Re: S.A. Dunn Construction and Demolition Landfill and Mine
DEC No.4-3899-00006

CITY OF RENSSELAER
SUPPLEMENTAL COMMENTS ON S.A. DUNN
CONSTRUCTION AND DEMOLITION DEBRIS
LANDFILL AND MINE

**DUNN C&D LANDFILL
IMPACTS ASSESSMENT**

November 10, 2022

PHOTO 9

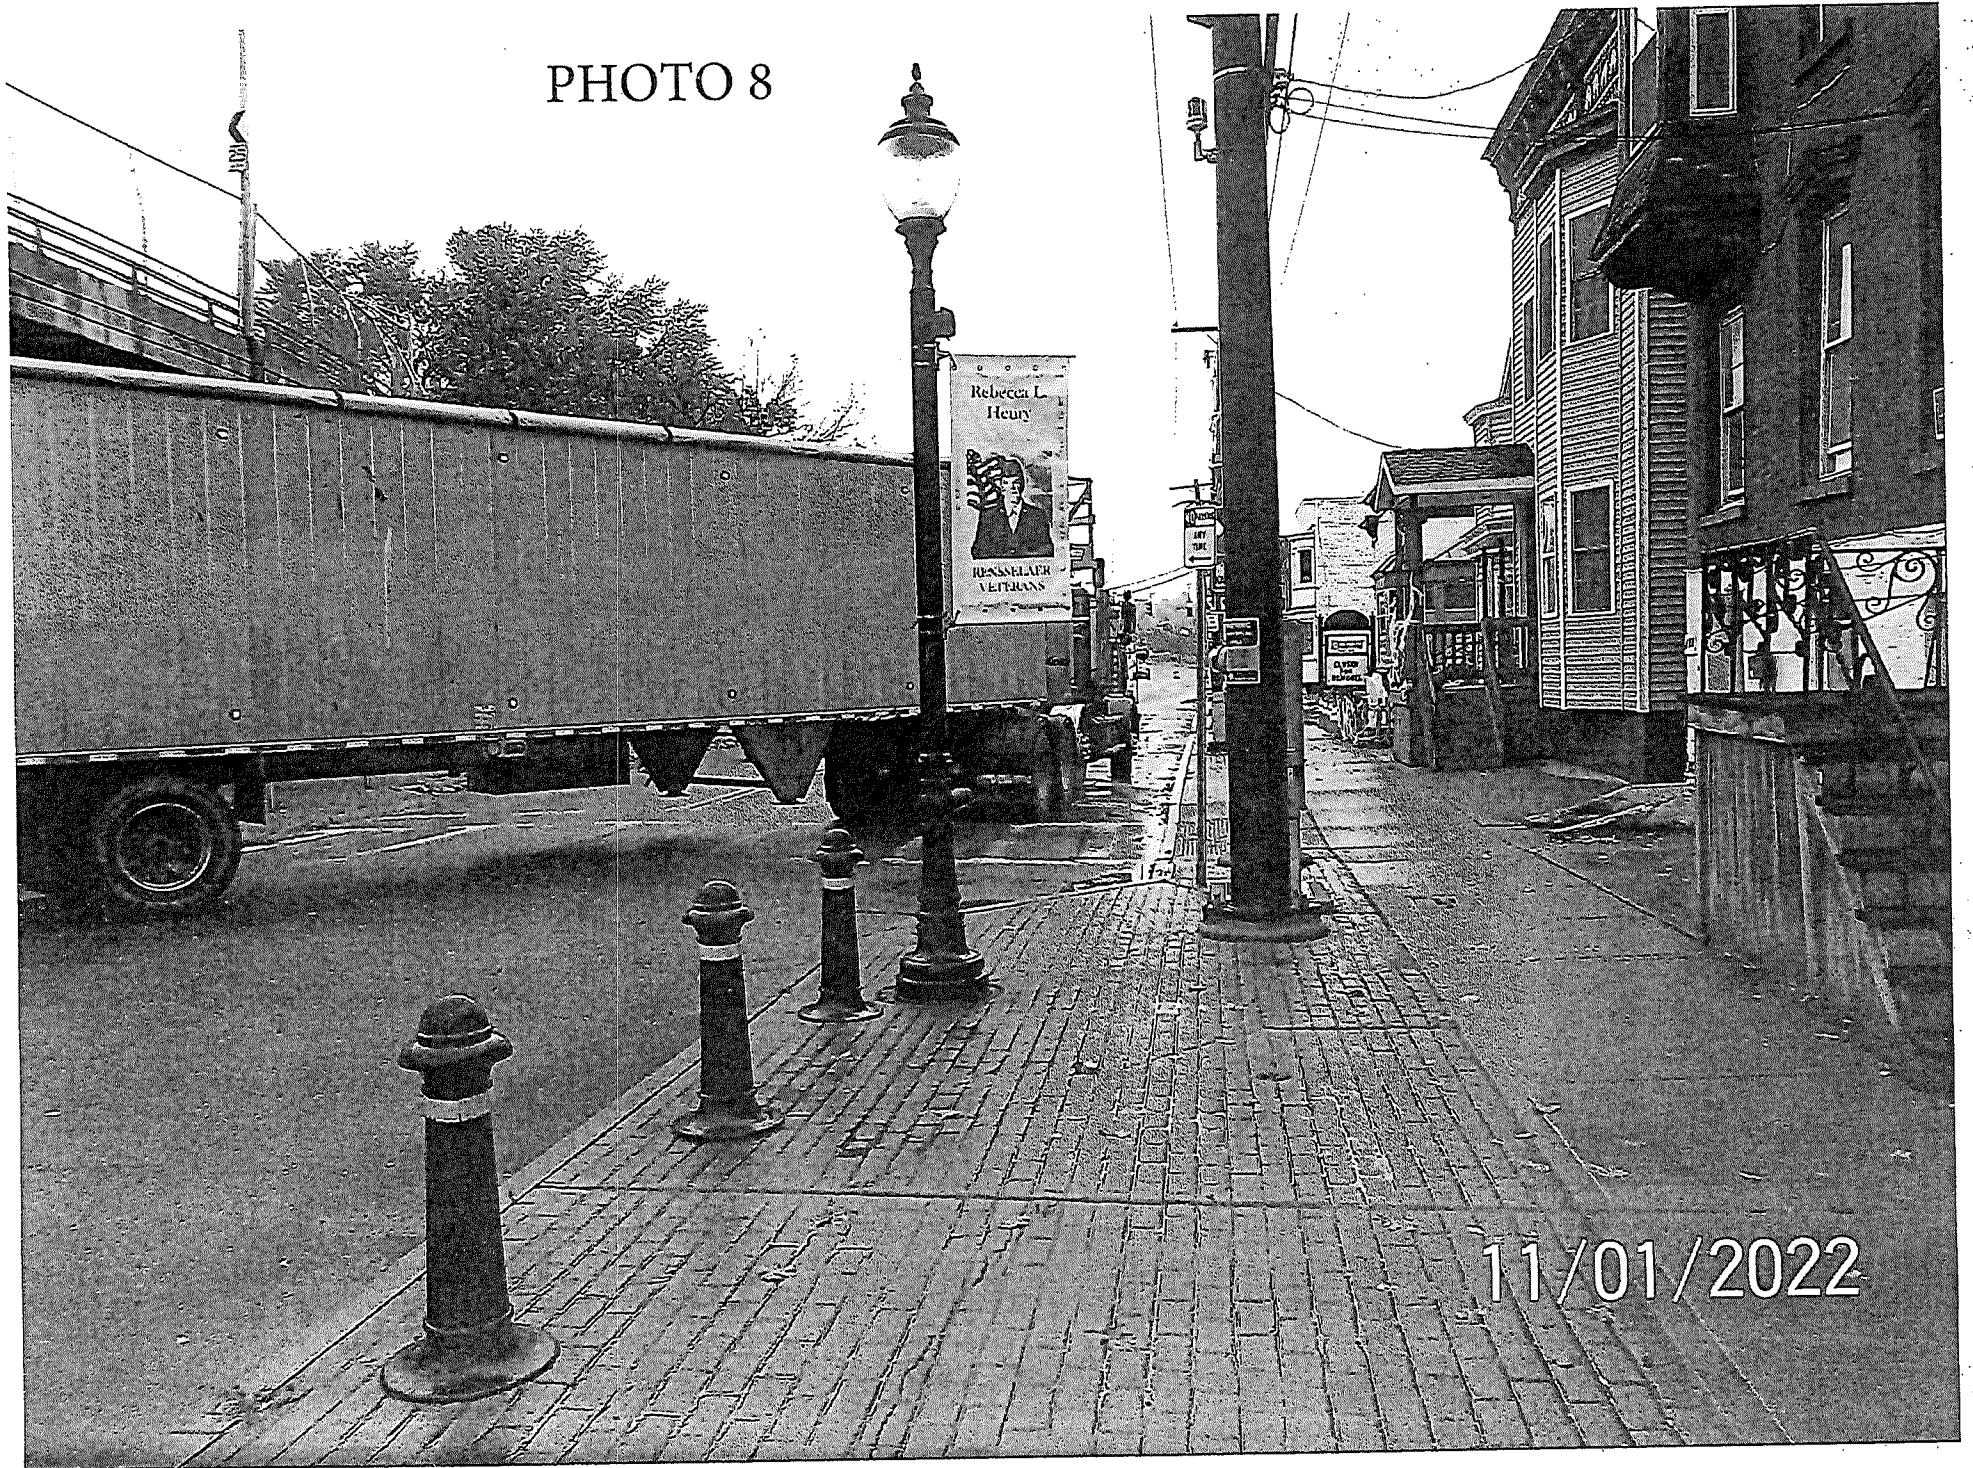
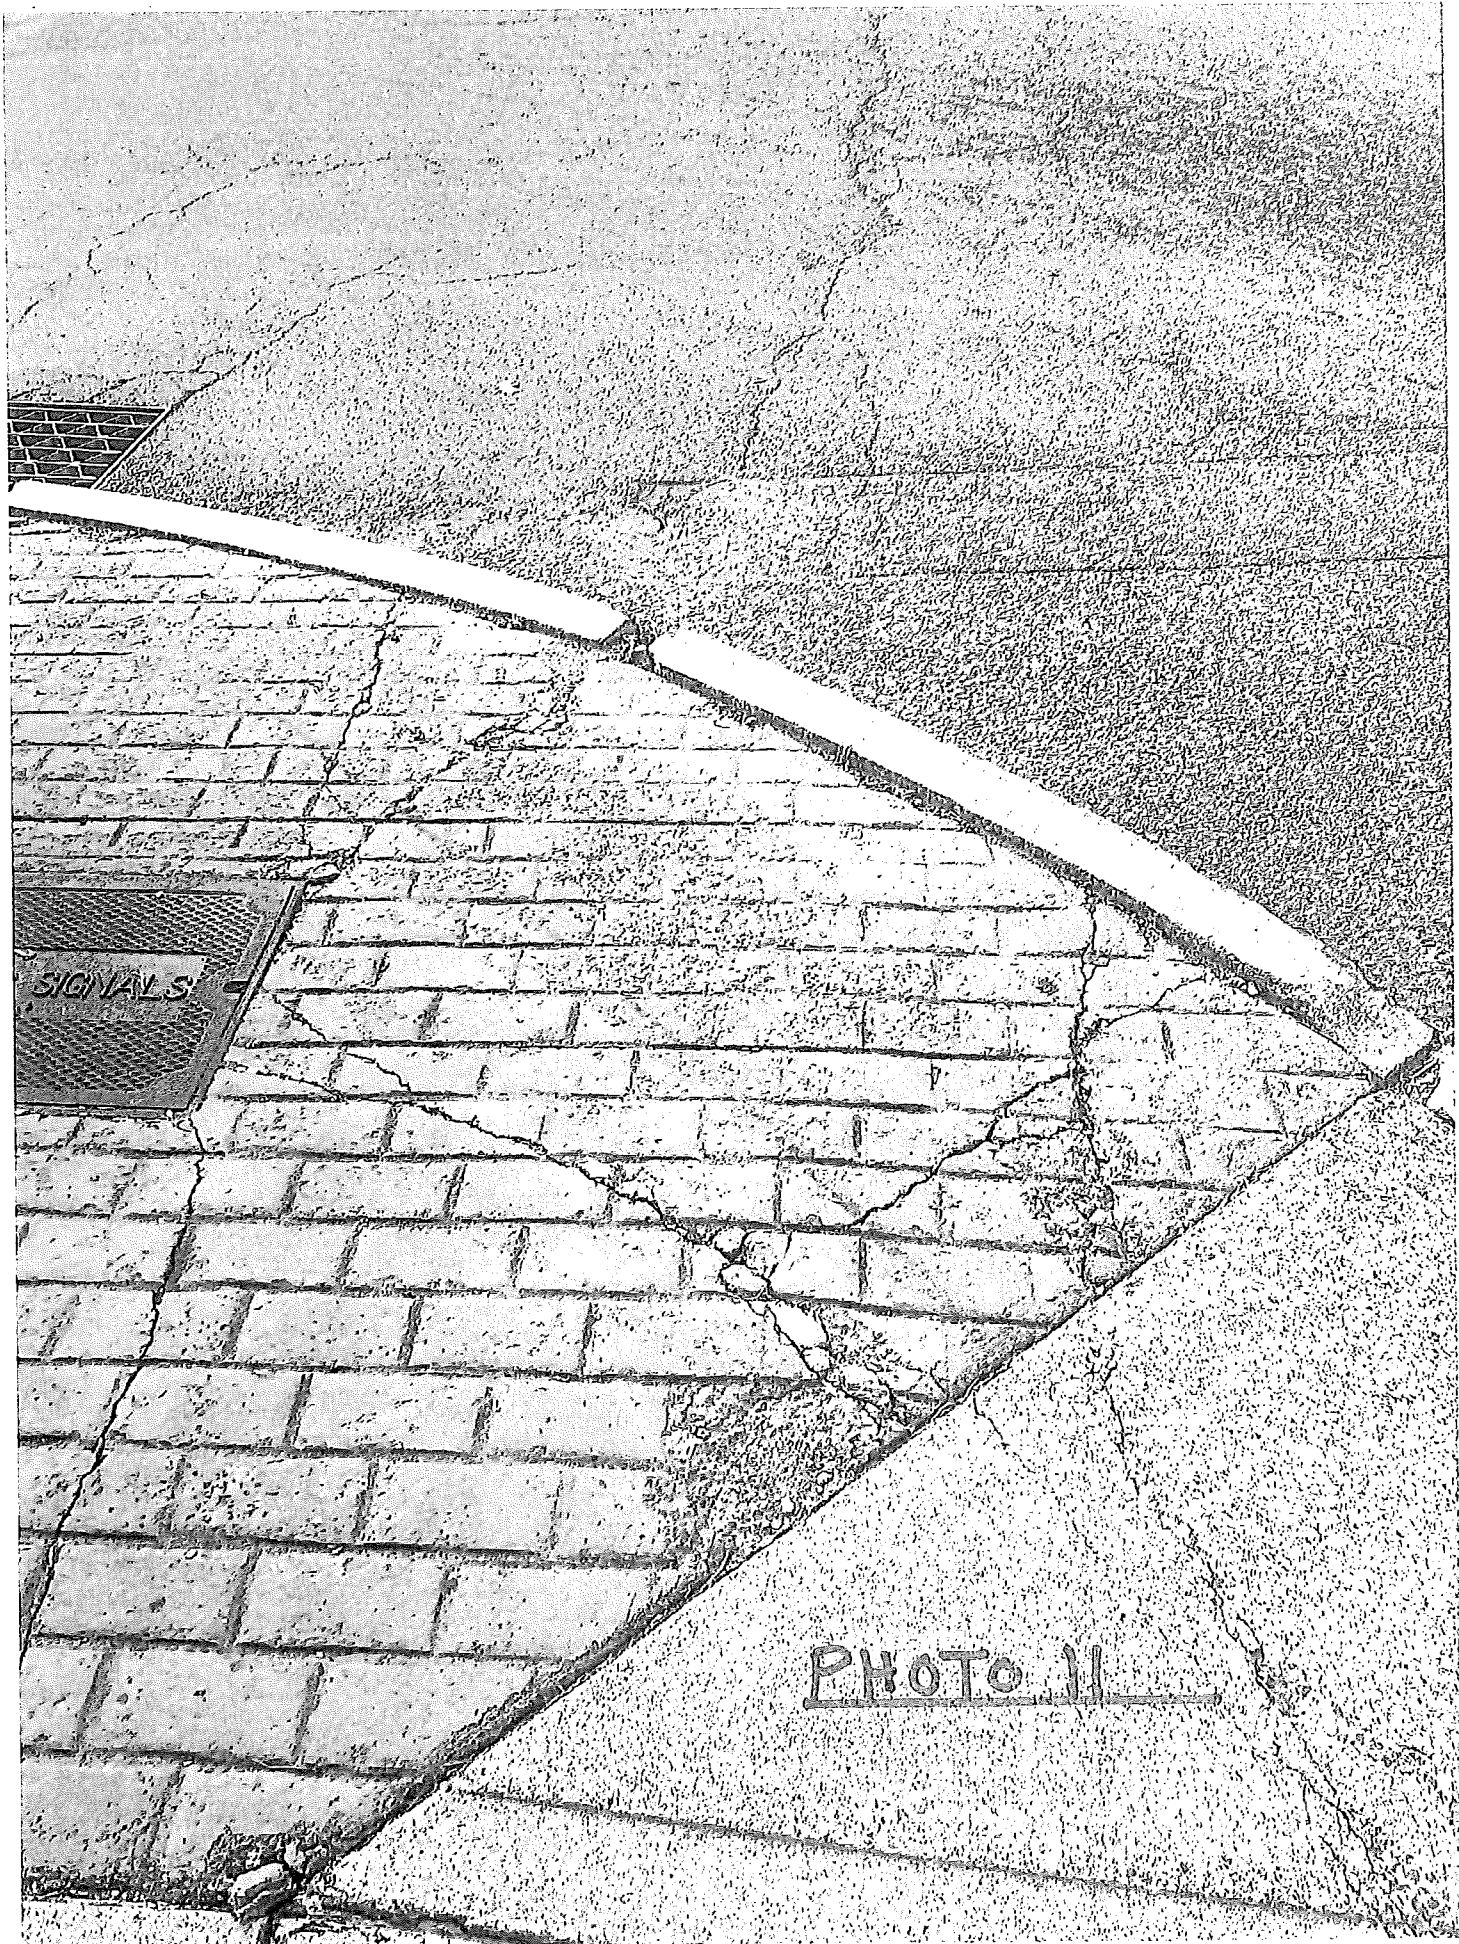
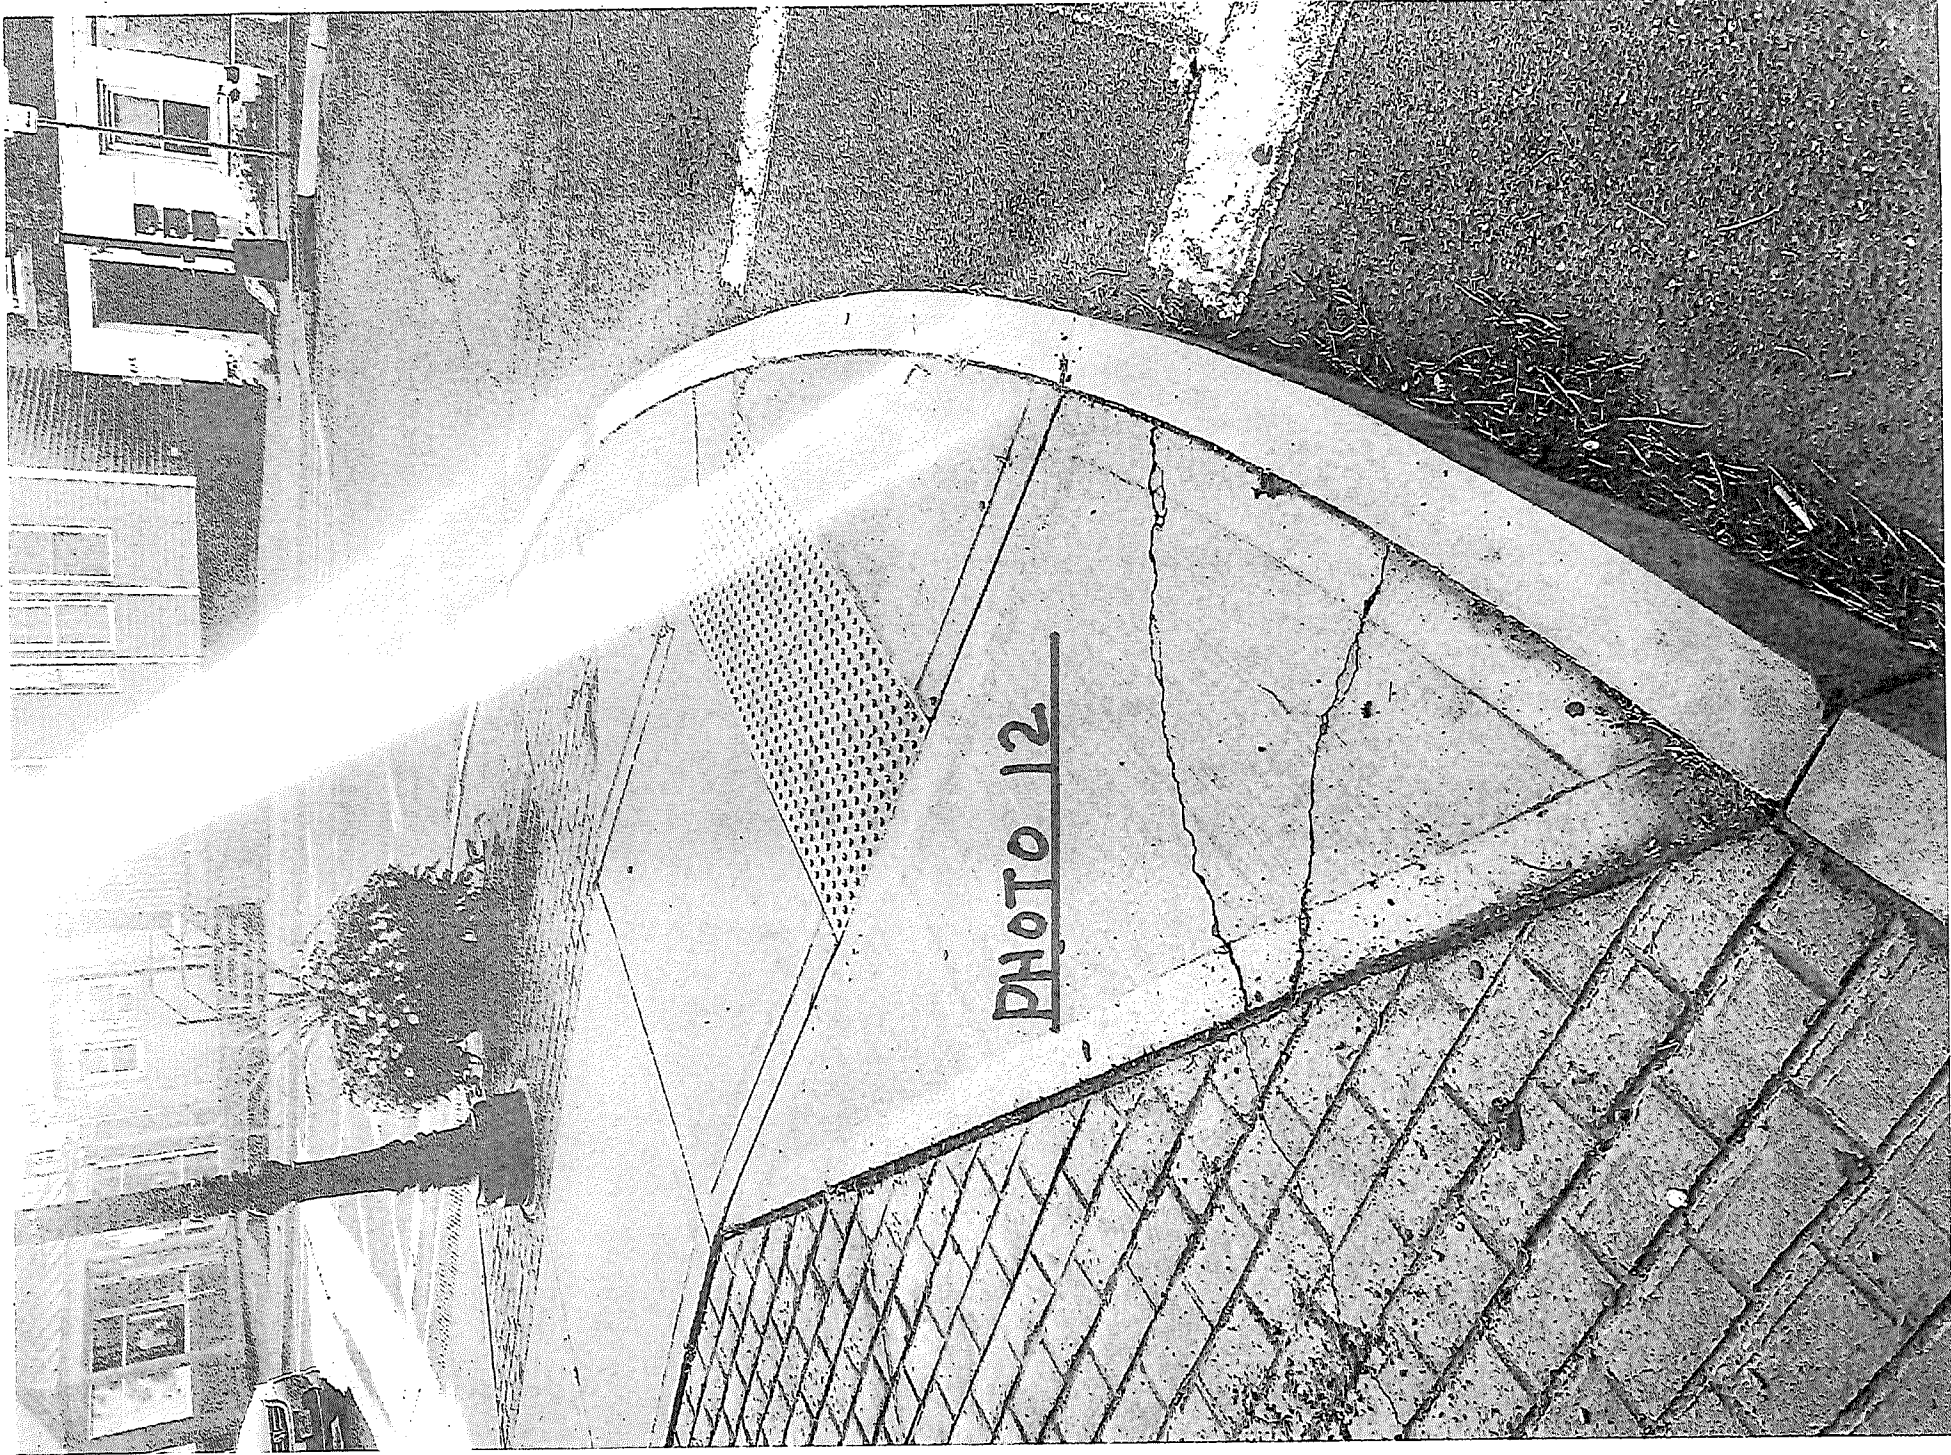
side walk making for pedestrian safety concerns and doing damage to the sidewalk and brick pavers. (see photos 9-12).

BROADWAY AT NEW BROADWAY - MAP 4

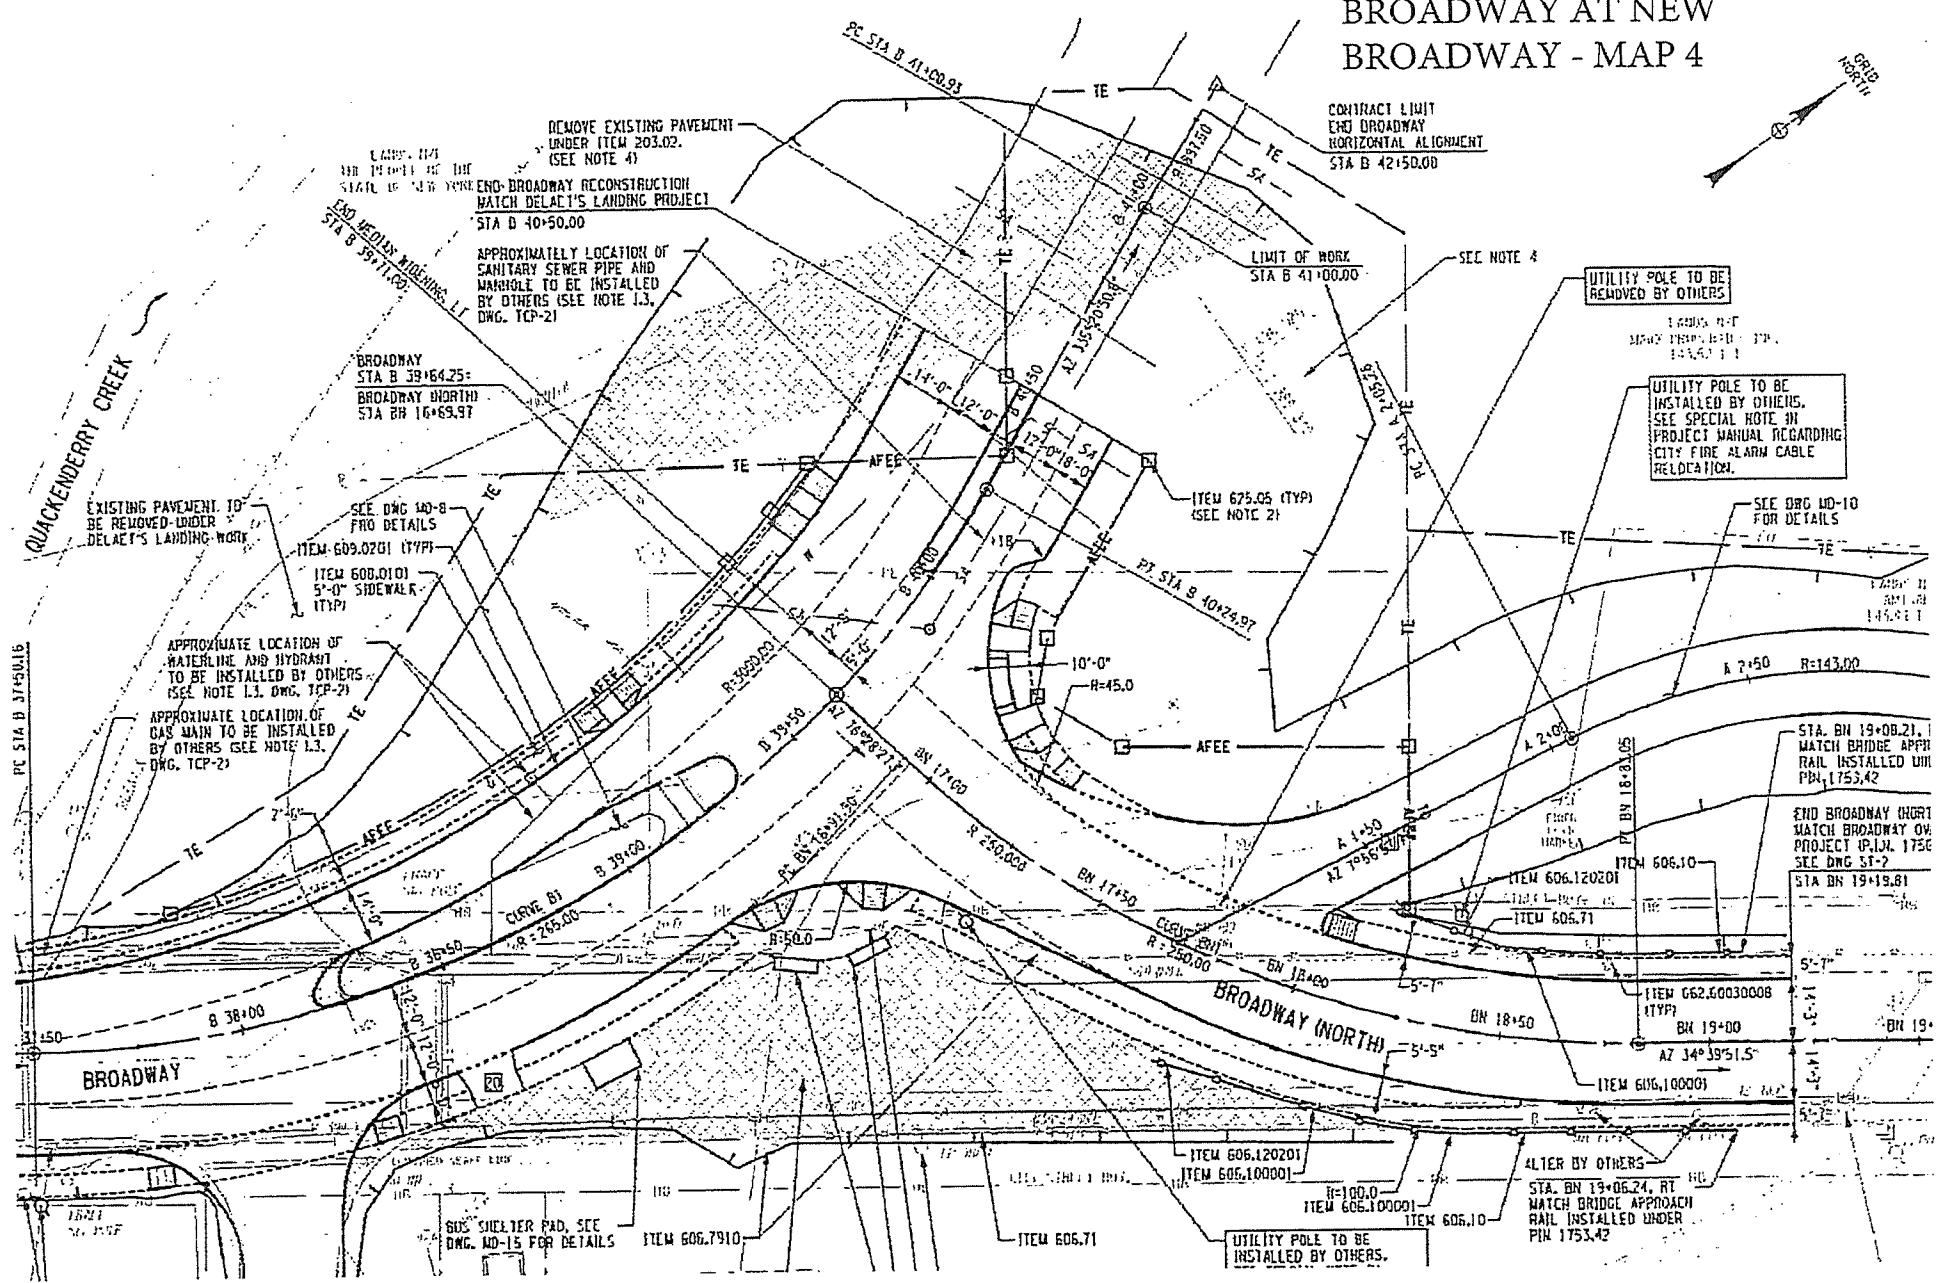
This is a fully signalized three way intersection. Going north bound (inbound) New Broadway is the thru movement while Broadway is a right turn (see Map 4). In this direction there is both a thru lane and a right turn lane. North and south bound lanes are separated by a striped median. All truck traffic accessing the Dunn Facility goes through this intersection.

The south bound (outbound) movement appears to work with some encroachment into the striped median. The north bound (inbound) right turn Broadway to Broadway does not appear to work well. Tractor trailers making this move when other traffic is stopped south bound cannot turn without encroaching into the thru lane and sometimes into the striped median (see photos 13-15). This creates a dangerous situation which is increased when other traffic is stopped at Broadway and New Broadway south bound.
